ADDENDUM 1
BID PROPOSAL NO. 1144
PARTIAL WINDOW REPLACEMENT – BYERS HALL – ALLGHENY CAMPUS
AUGUST 20, 2025

BID PROPOSAL NO. 1144
PARTIAL WINDOW REPLACEMENT – BYERS HALL - ALLEGHENY
CAMPUS

CCAC
PARTIAL WINDOW REPLACEMENT
- BYERS HALL
AUGUST 20, 2025

W1.1

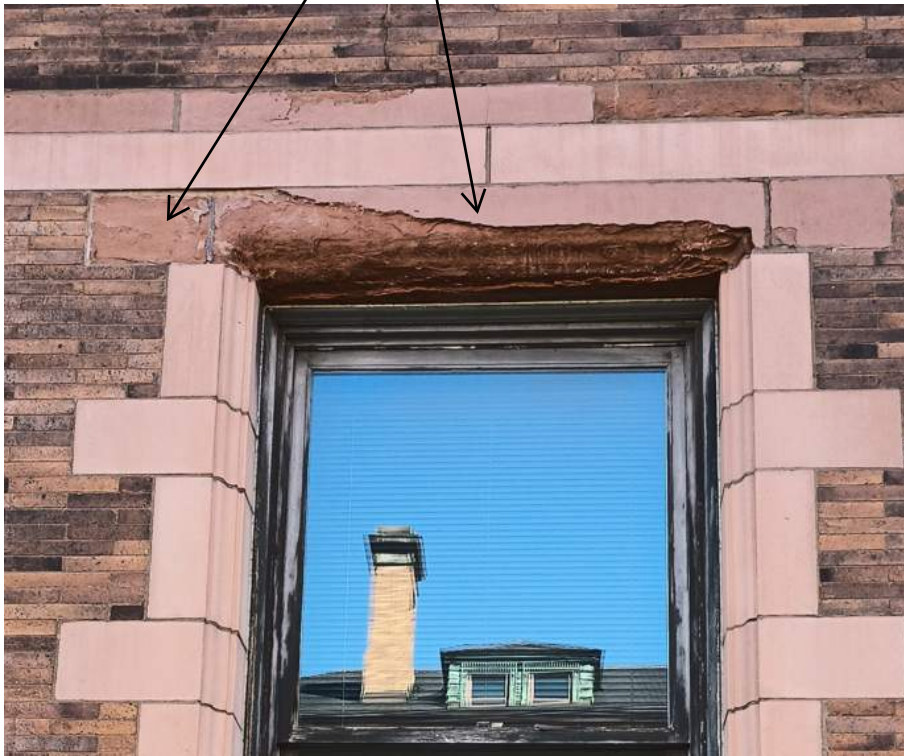
6. For information, Mariani & Richards Inc. completed some masonry repairs on Byers Hall under a previous project.
7. At the west wall, the window to the right that is noted to repair/replace existing stone lintel, the small stone to the left of the window and the main stone lintel above the window are to be replaced. The small stone piece to the right shall remain. See drawing W1.1 dated August 20, 2025

THE TWO PIECES OF STONE LINTEL
THAT ARE TO BE REPLACED. PROFILE
AND COLOR OF STONE TO MATCH
EXISTING. CONTRACTOR TO PROVIDE
SAMPLES OF STONE FOR REVIEW BY
OWNER AND ARCHTTECT
